RS-14-195

Braidwood Station, Units 1 and 2  
Facility Operating License Nos. NPF-72 and NPF-77  
NRC Docket Nos. STN 50-456 and STN 50-457

Subject: Third Six-Month Status Report in Response to March 12, 2012 Commission Order Modifying Licenses with Regard to Reliable Spent Fuel Pool Instrumentation (Order Number EA-12-051)

**Third Six-Month Status Report for the Implementation of Order EA-12-051, Order  
Modifying Licenses with Regard to Reliable Spent Fuel Pool Instrumentation**

Braidwood Station, Units 1 and 2 SFPI LAYOUT IN PLAN VIEW

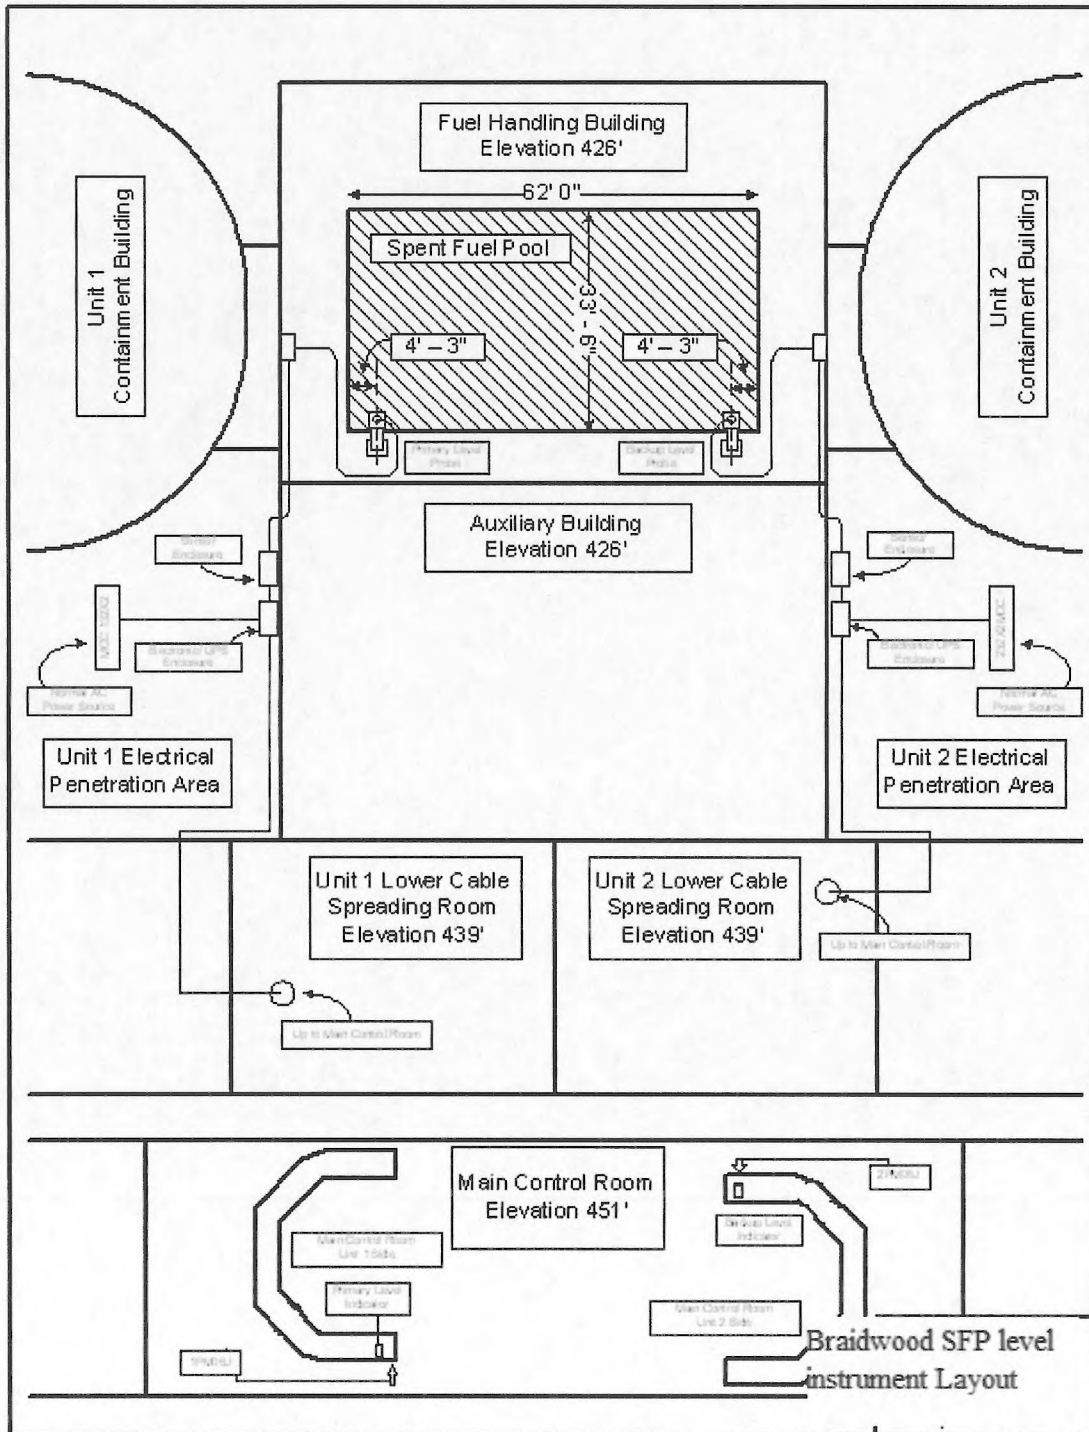
4 (RAI-2, Ref.4)	<p><u>RAI Question:</u></p> <p><b>Provide a clearly labeled sketch or marked-up plant drawing of the plan view of the SFP area, depicting the SFP inside dimensions, the planned locations/placement of the primary and backup SFP level sensor, and the proposed routing of the cables that will extend from the sensors toward the location of the read-out/display device.</b></p>	<p><u>Complete.</u></p> <p>The marked-up sketch is provided in Attachment 1, attached with this submittal.</p>
5	<u>RAI Question:</u>	<u>Complete.</u>
